Access Compliance Report

Public Rights-of-Way

(Curb Ramps)

Intersection ID: 22146	Main Street: E_HEBRON_ST	Cross Street: NATIONS_FORD_RD	Location: SE
ADA ID: 262ED5AD01C9	Ramp Type: PerpDiag	Initial Pass/Fail: Fail	Overall Compliance: No
Severity Score: 33.75			
Codes/Mitigation Info/Possible Solution		Field Measurements/Component Compliance

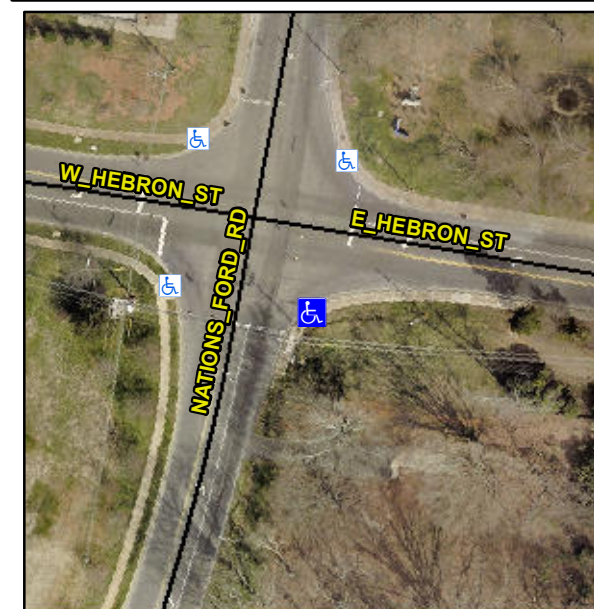
Not Found, R304.5.1, R304.2.2, R304.5.3

Compliance	Description	Data	Compliance	Description	Data
N/A	Ramp Length (in)	60.0	No	Ramp Slope (%)	9.1
No	Ramp Width (in)	46.0	No	Ramp XSlope (%)	6.7
N/A	Flare Type LT	N/A	N/A	Flare Type RT	N/A
N/A	Flare Slope LT (%)	N/A	N/A	Flare Slope RT (%)	N/A
N/A	Flare Traversable LT?	N/A	N/A	Flare Traversable RT?	N/A
N/A	Landing Length (in)	N/A	N/A	DWS Provided?	N/A
N/A	Landing Width (in)	N/A	N/A	DWS Contrast?	N/A
N/A	Landing Slope (%)	N/A	N/A	DWS Length (in)	N/A
N/A	Landing X Slope (%)	N/A	N/A	DWS Full Width?	N/A
N/A	Landing Curb? (Y/N)	N/A	N/A	DWS Offset (in)	N/A
N/A	Shared Landing?	N/A			
N/A	Gutter Ponding?	N/A	N/A	Gutter Slope (%)	N/A
N/A	Gutter Lip Ht (in)	N/A	N/A	Gutter X Slope (%)	N/A
N/A	Painted X Walk1?	No	N/A	Painted X Walk2?	No
	X Walk 1 Direction	To NE		X Walk 2 Direction	To NW
N/A	X Walk 1 Width (in)	N/A	N/A	X Walk 2 Width (in)	N/A
	X Walk 1 Slope (%)	0.5		X Walk 2 Slope (%)	5.6
	X Walk 1 X Slope (%)	6.1		X Walk 2 X Slope (%)	0.7

Remove & Replace Curb Ramp With Two New Directional Ramps or Equivalent.
